From: McConnell, DAVE P <dave.p.mcconnell@lmco.com>
Sent: Monday, March 06, 2017 6:40 AM
To: Grant Robinson
Subject: ASB 92-63-044 MGB Slider Bushings 920279

Case Number: C0054755
Customer: Thai Aviation Services Limited
Aircraft S/N: 920279
Aircraft Model: S-92A
Aircraft TT: 804
ATA: 63
Part Number: 92351-15100-050
Case Subject: ASB 92-63-044-Mixed Bushing Configuration

**Aft mount foot
MGB S/N A171-00310
A/C S/N 920279**

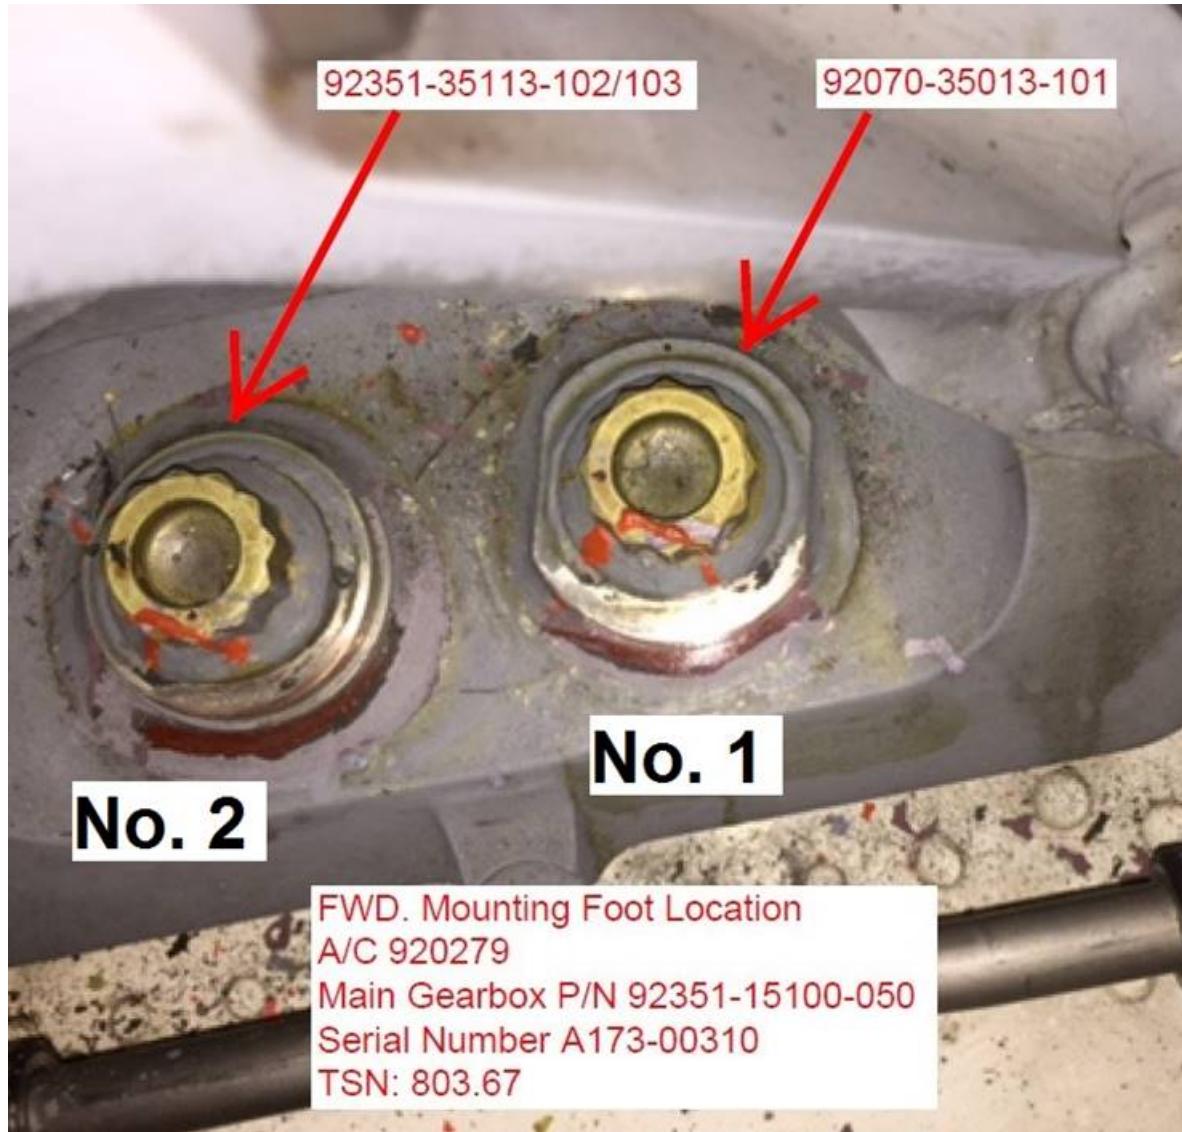
TAS maintainers performing ASB 92-63-044 – Inspection of Forward and Aft MGB Mounting Feet Bushings – on A/C S/N 920279 MGB P/N 92351-15100-050 S/N A173-00310 TSN 803.7 found mixed configurations of bushings on both the forward and aft feet.

The forward mount foot has a P/N 92070-35013-101 bushing in the No. 1 position and a P/N 92351-35113-102/-103 bushing in the No. 2 position.

The aft foot was identical: P/N 92070-35013-101 in the No. 6 position and P/N 92351-35113-102/-103 in the No. 5 position.

All bushings were found to have the correct height measurement. No gaps were noted under any bushing.

This type of mixed configuration is not clearly called out in the ASB.

TAS requests confirmation on an AOG basis that the A/C may be returned to service with the mixed bushing installation described above. EoM

Sikorsky Engineering states to proceed with the inspection per, ASB 92-63-044, Section.3. for ALL four bushings.
